Agenda Item # 8

SUB-003743-2026

Marshall Addition to Myrtlewood Lane Subdivision

- Subdivision approval to create two (2) legal lots of record from one (1) metes-and-bounds parcel.

DETAIL SITE PLAN

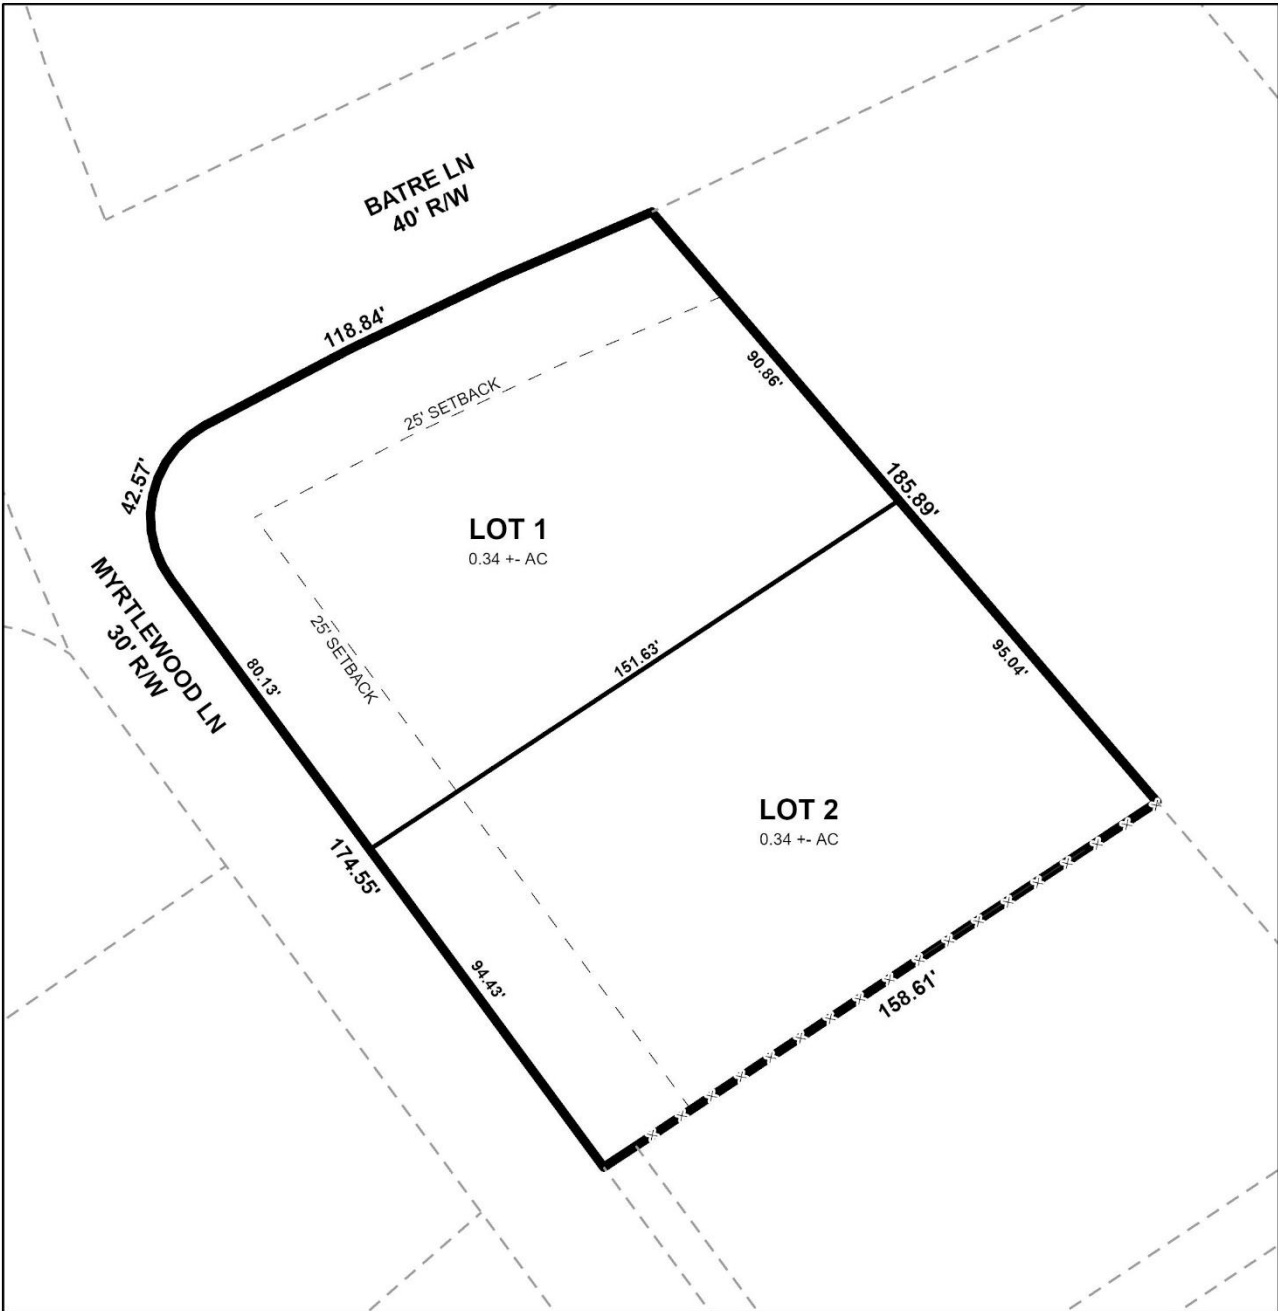
The lots front Myrtlewood Lane and Batre Lane. Both are minor streets with curb and gutter improvements, each requiring a 50-foot-wide right-of-way. The preliminary plat illustrates a 40-foot right-of-way width along Batre Lane and a 30-foot right-of-way width along Myrtlewood Lane. If approved, dedication to provide 25-feet from the centerline of Myrtlewood Lane and 25-feet from the centerline of Batre Lane should be required and illustrated on the Final Plat, unless a waiver of Section 6.B.9. of the Subdivision Regulations is recommended by the City Engineer and Traffic Engineer.

A 25-foot corner radius is depicted where Myrtlewood Lane and Batre Lane intersect, in compliance with Section 6.C.6. of the Subdivision Regulations. This information should be retained on the Final Plat, if approved.

The lots are properly labeled with their sizes in both square feet and acres on the preliminary plat, as required by Section 5.A.2(e).4. of the Subdivision Regulations. If approved, this information should be retained on the Final Plat, adjusted for any required dedication; alternatively, a table providing the same data is acceptable.

A 25-foot minimum front yard setback is illustrated along Myrtlewood Lane and Batre Lane, as required by Section 6.C.8. of the Subdivision Regulations and Article 2, Section 64-2-5.E. of the UDC. If approved, this information should be retained on the Final Plat, adjusted for any required dedication.

1. Dedication to provide 25 feet from the centerline of Myrtlewood Lane, unless a waiver of Section 6.B.9 is recommended by the City Engineer and Traffic Engineer;

2. Dedication to provide 25 feet from the centerline of Batre Lane, unless a waiver of Section 6.B.9 is recommended by the City Engineer and Traffic Engineer;

3. Retention of the 25-foot corner radius at the intersection of Myrtlewood Lane and Batre Lane, in compliance with Section 6.C.6. of the Subdivision Regulations;

4. Retention of the lot sizes in both square feet and acres, or provision of a table on the Final Plat with the same information, adjusted for any required dedication;

5. Retention of the 25-foot minimum building setback line along Myrtlewood Lane and Batre Lane, adjusted for any required dedication;
6. Compliance with all Engineering comments noted in this staff report;
